URGENT MEDICAL DEVICE CORRECTION

Re: PENTAX Medical Video Processors Software Update for EPK-i8020c for Light Limit Mode

Update to Instruction for Use (IFU).

REF: 2025-002-C

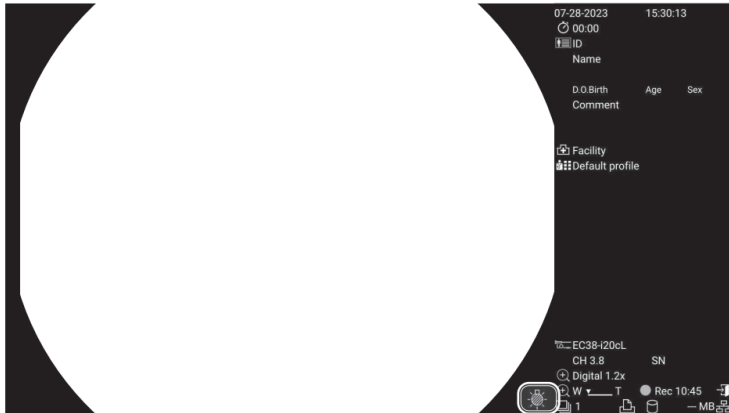
Note:

- When Light Limit Mode is turned on, the amount of light decreases. If you notice reduced light output, please check that Light Limit Mode is not activated.
- White balance cannot be performed when Light Limit Mode is on.

How to Use Light Limit Mode

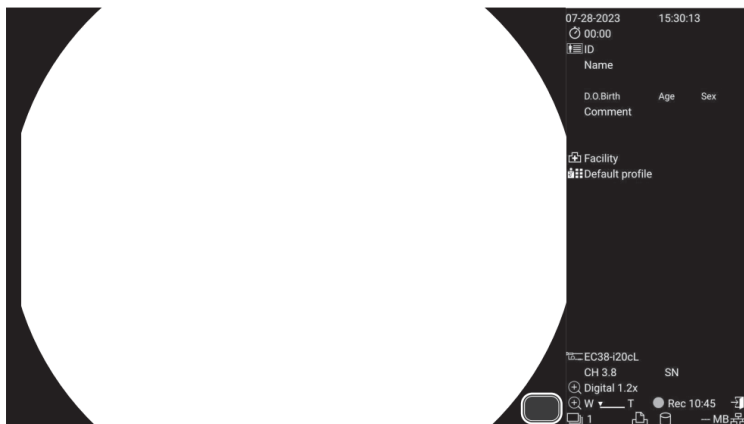
1. To activate Light Limit Mode, touch and hold the button. The button will turn blue, and the light emitted from the tip of the endoscope will decrease.

2. When Light Limit Mode is enabled, an icon will be displayed on the monitor screen.

3. To deactivate Light Limit Mode, touch and hold the button again. The button will return to its original color, and the light emitted from the distal end of the endoscope will return to its previous intensity.

4. After deactivating Light Limit Mode, the icon will disappear from the monitor screen, indicating that the light emission has returned to its normal intensity.
